AS-BUILT

VESSEL: FRV40 CLASS 63m FISHERIES RESEARCH VESSEL

TITLE: HULL STERNBODY SCANTLINGS FR. 49 – FR. 82

DWG NO. M282-110-FH04 SH 1

SECTION 24–C ⚠5
WT TRANSV BHD FR 58
LKG FWD

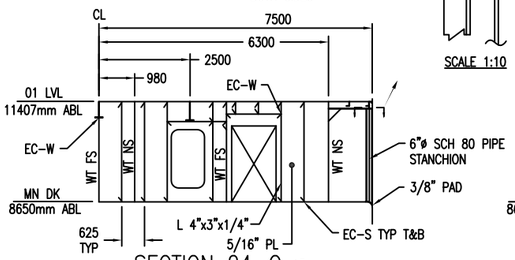
REV	ZONE	DESCRIPTION	DATE	APPROVED
3 CONT'D		4. SHT 2, PLAN 10-C: ADDED ELEV. 22-B CALL-OUT TO LONG'L BHD. 5. SHT 3, SECT. 24-C: REVISED BHD TO SUIT NEW DOOR SIZE AND LOCATION. ADDED ELEV. 22-B FOR LOG'L BHD 980 OCL (S). ITEMS 1-3 PER ENG. DEVELOPMENT. ITEMS 4 & 5 PER PRN 002 DTD. 1/31/05.		
4		1. SH 1, EXTENDED HULL APPLICABILITY TO INCLUDE HULL 1957. 2. SH 1, ADDED SH 8 TO DRAWING INDEX. 3. SH 2, ELEVATION 10-C, CHANGED PLATE THICKNESS TO 1". 4. SH 2, ELEVATION 10-C, ADDED NOTE FOR APPLICABILITY. 5. SH 3, ELEVATION 21-B, ADDED NOTE FOR APPLICABILITY. 6. SH 3, ELEVATION 22-B, ADDED NOTE FOR APPLICABILITY. 7. SH 4, SECTION 27-C, ADDED NOTE FOR APPLICABILITY. 8. SH 5, SECTION 39-A, ADDED NOTE FOR APPLICABILITY. 9. SH 7, ELEVATION 54-A, ADDED NOTE FOR APPLICABILITY. 10. SH 8, ADDED TO SHOW SCANTLINGS SPECIFIC TO HULL 1956. ITEMS 1 THRU 3 PER ENGINEERING DEVELOPMENT ITEMS 4 THRU 10 PER ECP 056B.	7/18/06 MDP	7/24/06 SM

ELEVATION 20–C ⚠1,10⚠3
LKG TO PORT
STBD SIDE CRANE PEDESTAL

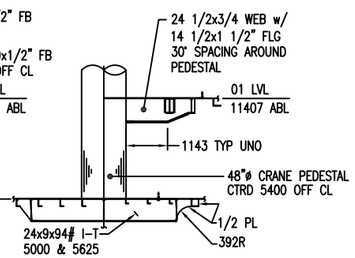
REV	ZONE	DESCRIPTION	DATE	APPROVED
1		1. SH 3, ELEV. 20-C: REVISED LONG'L GIRDER TRANSITION BKT FROM STRAIGHT TO RADIUS CUT TO CLEAR HPU MOTOR PULL SPACE. 2. SH 5, SECT. 36-4: DELETED 1/4 PL BKTS (NS) W/4x3/8 RIDER PLATES AND REINSTATED L4x3x1/4 TO SUIT REMOVAL OF BUILT-IN WINCH FOUNDATION. 3. SH 5, SECT. 36-C: DELETED 3/8 PL TAB LOCATED IWO CL ABOVE 4500 FLAT FOR BUILT-IN WINCH FDN. PLATE REMOVED TO SUIT REMOVAL OF SAID WINCH FDN. 4. SH 5, SECT. 34-B: DELETED BUILT-UP FLOOR STRUCTURAL ASSY ABOVE 4500 ABL TO SUIT REMOVAL OF BUILT-IN WINCH FDN. 5. SH 5, SECT. 34-D: DELETED 1/4 PL BKTS (NS/FS) W/4x3/8 RIDER PLATES AND REINSTATED L4x3x1/4 TO SUIT REMOVAL OF BUILT-IN WINCH FDN. 6. SH 7, ELEV. 54-A: DELETED BUILT-UP FLOOR STRUCTURAL ASSY ABOVE 4500 ABL TO SUIT REMOVAL OF BUILT-IN WINCH FDN. 7. SH 7, PLAN 55-C: DELETED RAISED PLATFORM USED AS PART OF WINCH FDN. 8. SH 2, PLAN 14-C: REVISED DIMENSIONS TO LONG'L DECK GIRDER BELOW STBD CRANE PEDESTAL FROM 5000 TO 5290 AND FROM 625 TO 570 TO SUIT RELOCATION OF STBD CRANE PEDESTAL. 9. SH 2, PLAN 10-C: RELOCATED STBD CRANE PEDESTAL FROM 5400 TO 5700 OCL AND REVISED DK STRUCTURE AS FOLLOWS; REDUCED SIZE OF 3/4" INSERT PL FROM 5000 x 2700 TO 3400 x 2700, DELETED TWO OUTBD. RADIAL GIRDERS AND REVISED DK OVERHANG STIFFENERS TO SUIT, REVISED TRSV. GIRDERS AT FRS. 78 AND 79 TO STOP AT LONG'L BHD 6300 OCL, DELETED 19 1/2 x 1/4 COAMING AT FRS 78 & 79, AND CHANGED END CONNECTION "EC-W" EXTENTS FROM FR. 69 – 77 TO FR. 69 – AFT FOR THE DK OVERHANG STIFFENERS. MODIFIED WEATHER-TIGHT BHD, 6300 OCL, WITH A KNUCKLE ADDED AT FRAME 81. 10. SH 3, ELEV. 20-C: REVISED LOCATION OF LONG'L GIRDERS FROM 5000 AND 5625 TO 5290 AND 5860 OCL, RESPECTIVELY. 11. SH 3, ELEV. 23-A: REVISED BHD TO SUIT RELOCATION OF CRANE PEDESTAL WITH THE FOLLOWING CHANGES; DELETED PORTLIGHT AT FR. 78, RELOCATED DOOR TO FR. 77, DELETED 1/2" PLATE INSERT, RELOCATED FREEING PORT FROM FR. 76 1/2 TO FR. 78 1/2, MODIFIED BHD STIFFENERS TO SUIT RELOCATION OF CUTOUTS, DELETED L8x4x5/16 FROM BHD, ADDED A KNUCKLE AT FR. 81 TO ALLOW THE BHD TO PERPENDICULARLY INTERSECT THE CRANE PEDESTAL. 12. SH 5, SECT. 34-A: RELOCATED STBD GIRDERS TO SUIT CRANE PEDESTAL RELOCATION. 13. SH 6, SECT. 42-A: RELOCATED STBD CRANE PEDESTAL FROM 5400 TO 5700 OCL AND SHIFTED DECK GIRDERS TO SUIT. REVISED BHD TO SUIT PEDESTAL RELOCATION WITH THE FOLLOWING CHANGES; EXTENDED HEADERS IWO BHD CUTOUT, EXTENDED BHD STIFFENERS TO MN DK THAT WERE IN LINE OF THE LONG'L DK GIRDERS, ADDED TWO NEW BHD STIFFENERS TO SUIT RELOCATED DECK GIRDERS. 14. SH 3, ELEV. 24-B: CHANGED 1/2" INSERT PL TO 5/16" THK. 15. SH 2, PLAN 10-C: ADDED 5/16" INSERT PL IWO NET REEL FOUNDATION, P/S. ITEM 1 PER PRN #001, DTD 1/28/04. ITEMS 2 THRU 7 PER REWORK #741-0004 ITEMS 8 THRU 15 PER ENGINEERING DEVELOPMENT	1/28/04 AGE 2/26/04 AGE 3/22/04 AGE 3/30/04 AGE	4/5/04 RG

ELEVATION 21–B ⚠5⚠2⚠3
NT/WT LONG'L BHD 2500 OCL PORT
LKG OUTBD
M282 ONLY
FOR M283 & M284 SEE ELEV 62–D

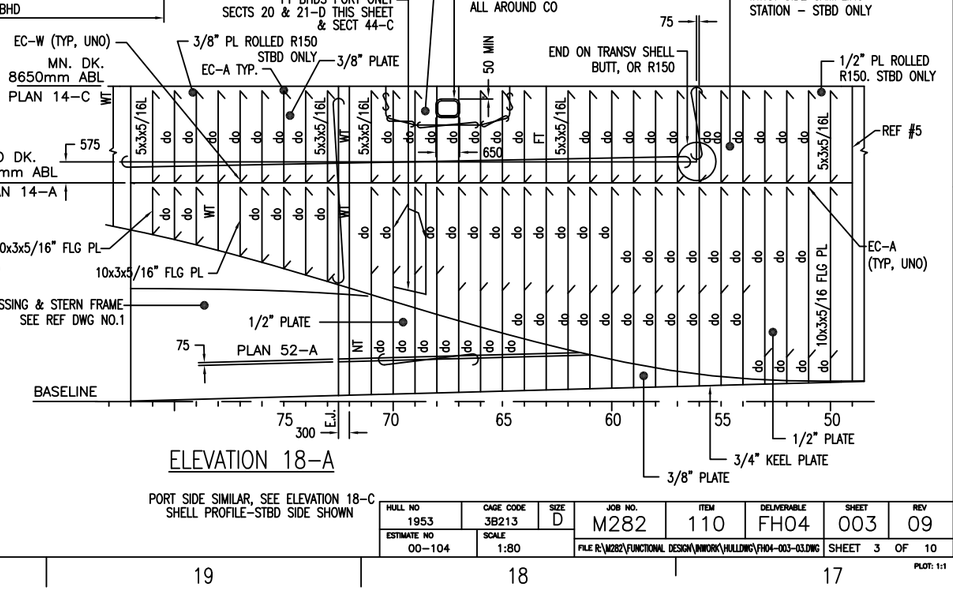
REV	ZONE	DESCRIPTION	DATE	APPROVED
6		1. SH 1, REFERENCES: ADDED REF #16, FH26 JOINER DOOR SCHEDULE, TO REFERENCES. 2. SH 3, ELEVATION 21-B: EXTENDED BHD TO FR 49 AND DETAILED CLEAR OPENINGS FOR STAIRWELL JOINER DOORS. 3. SH 8, ELEVATION 62-D: EXTENDED BHD TO FR 49 AND DETAILED CLEAR OPENINGS FOR STAIRWELL JOINER DOORS. 4. SH 1, ADDED SH 1A TO DRAWING INDEX AND REVISION STATUS. ITEM 1 THRU 3 PER ENGINEERING DEVELOPMENT	11/07/06 MDP	11/13/06 SM
7		1. SH 1, DRAWING INDEX & REVISION STATUS; ADDED SHT 10. PROPULSION XFMR MOVED AFT TO MAKE ADEQUATE SPACE BETWEEN XFMR AND GENERATOR FOR PASSAGE. SHT 10 DETAILS ADDITIONAL UNDERDECK STRUCTURE FOR XFMR RELOCATION. 2. SH 2, PLAN 14-A; ADDED NOTE REGARDING APPLICABILITY. CHANGED SCANTLING TWO 24"X24" EOS HATCH FOR M283/M284. 3. SH 7, ELEVATION 54-D, PLAN 54-C, ELEVATION 52-D & ELEVATION 51-D; ADDED NOTE REGARDING APPLICABILITY. ITEM 1 & 3 PER VENDOR CHANGE ITEM 2 PER ENGINEERING CHANGE THIS REVISION APPLICABLE TO M283/M284 ONLY	4/10/07 MDP	4/17/07 SM

SECTION 34-B ⚠4 ⚠3

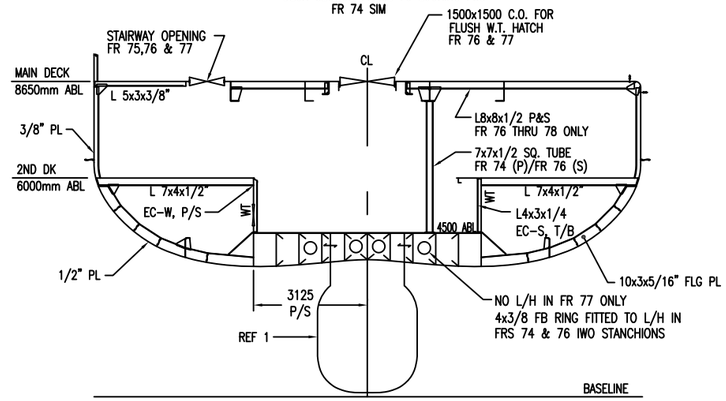
3		1. EXTENDED HULL APPLICABILITY TO INCLUDE HULL 1956. 2. SHT 3, ELEV. 23-B & 21-C: SPECIFIED PIPE STUB TO BE SHIPYARD SUPPLIED. 3. SHT 5, SECT. 34-B REVISED CALLOUT TO INCLUDE FR 74 TO BE FITTED W/ FB IWO LH. (CONT'D ZONE 4-D)	3/21/05 RMW	3/30/05 RG

PLAN 51-C [3,4,5]

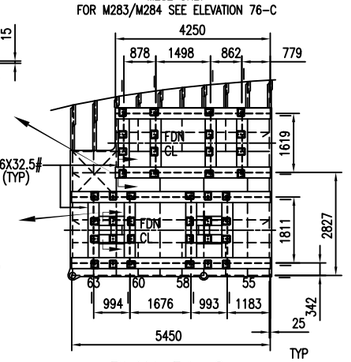
5		1. SH 1, THIS REVISION REFLECTS AS-BUILT CONDITIONS FOR HULL 1953. 2. SH 1, ADDED SH 9 TO DRAWING INDEX AND REVISION STATUS. 3. SH 1, ADDED GENERAL NOTE #17 SPECIFYING SURFACE TOLERANCES FOR GENERATOR FOUNDATION. 4. SH 7, PLAN 51-C, ADDED NOTE REGARDING APPLICABILITY. 5. SH 7, PLAN 51-C, ADDED STRUCTURE TO M282 GENERATOR FDN TO MATCH AS-BUILT CONDITION. ITEMS 1 THRU 5 PER ENGINEERING DEVELOPMENT	8/22/06 MDP	9/6/06 MDP
